NOTICE OF DECISION

Order 2022-06 Crestview Green CUP22-0001/PUD22-0001

Re: CUP22-0001 & PUD22-0001 4813 & 4821 E Portland Road

PLANNING COMMISSION ORDER 2022-06

Figure 1: East/West Sun Exposure Diagram - Attached Units

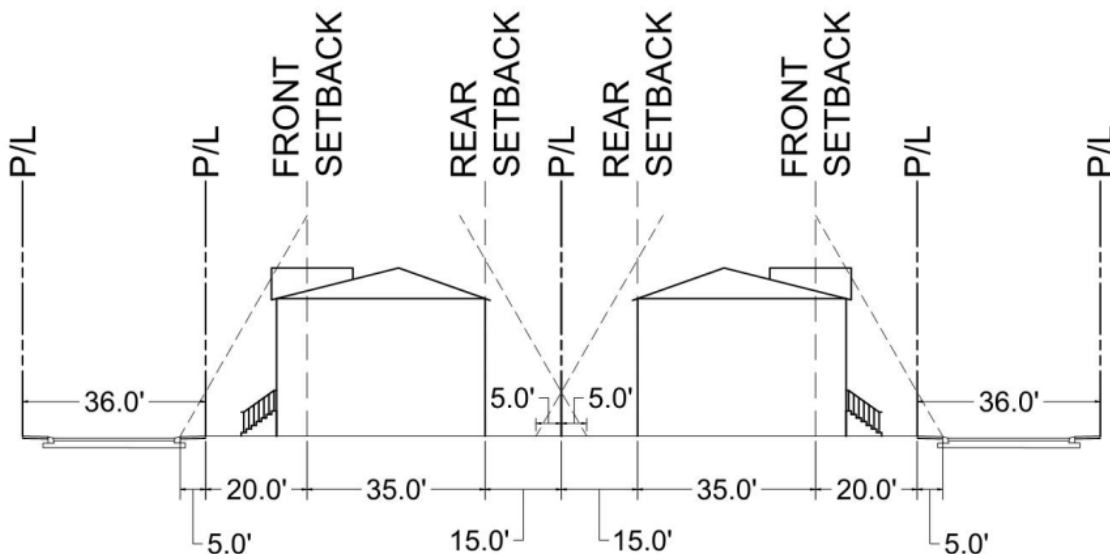
The Applicant has provided a sun exposure diagram and analysis. The applicant is proposing 3-story units that may impact sun exposure in the R-2 and C-2 districts.

It is up to the hearing authority, in this case the planning commission, to determine if lack of sun exposure will or will not adversely affect the occupants or potential occupants of adjacent properties. Even houses in existing subdivisions that have not been granted relaxations of dimensional requirements, such as lot width and setback, block the sun to some extent of neighboring houses. Because existing neighboring houses in previously developed subdivisions block sun exposure to some extent and would have impacts to sun exposure on only the first floor of their homes and not the entire house these criteria are met.

Figure 2: North/South Sun Exposure Diagram - Attached Units

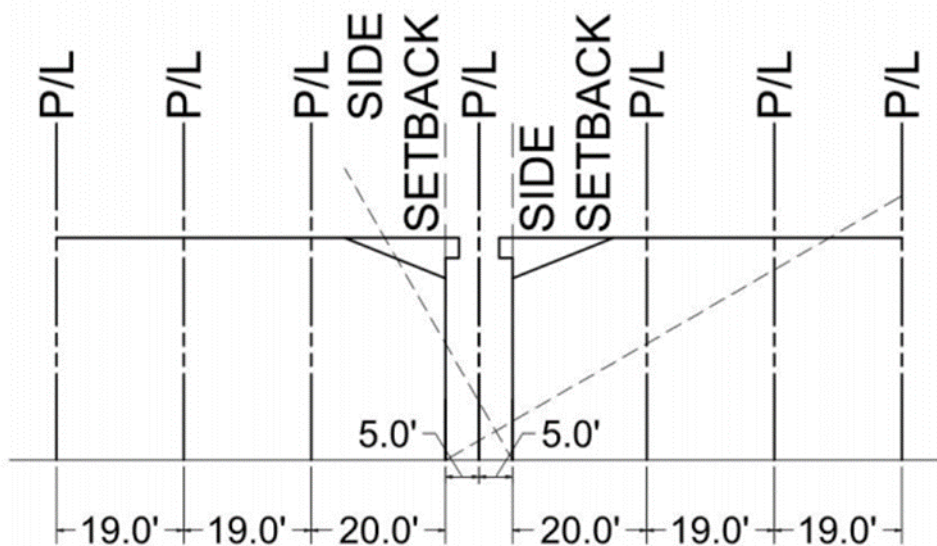
The Applicants’ narrative states “The side yards of the attached homes are subject to the north/south sun exposure plane orientation. The proposed homes are townhome style units, with the majority of the sides of the units being attached with no sun exposure. Units located at each end of the private streets will meet the sun exposure plane requirements. A total of 28 units will not meet the sun exposure plane requirements of NMC 15.05.030 as illustrated in the Figure 2 below. Each of these 28 units will have a five-foot setback from the property line and 10 feet

from the adjacent building. As stated previously, the ground floor of each attached unit will be occupied by a garage. Upper floors will have minimal windows along each side, with main windows located at the front and back of each home, rather than along each side. Open concept floor plans in the attached units will allow for sun exposure to be brought further into each unit. The benefits of housing configured within this manner provides numerous benefits to the future residents and provides opportunities for the creation of a highly efficient and well-designed community. In order to meet the requirements for minimum density, site configuration, parking, block length, and access, the Applicant requests a departure from the strict application of this code from the Planning Commission.”
